BRYANT HEIGHTS LLC

BOARD RECOMMENDATIONS FROM PREVIOUS MEETING:

24 FEBRUARY 2014

SCHEME A

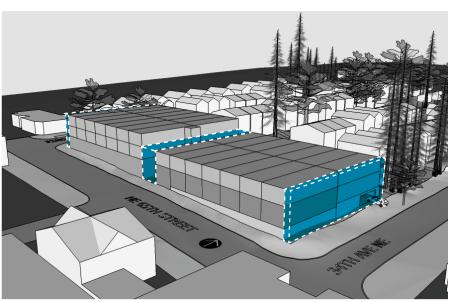
- In responce to EDG comments, openspace has been allocated to middle section of 3-story mass with 17'-6" wide open space on west side of the building and 5' open space on east side of building
- (28) 2-story and 1-story residential units
- (8) live-work units
- up to 6,377 s.f. of retail commercial
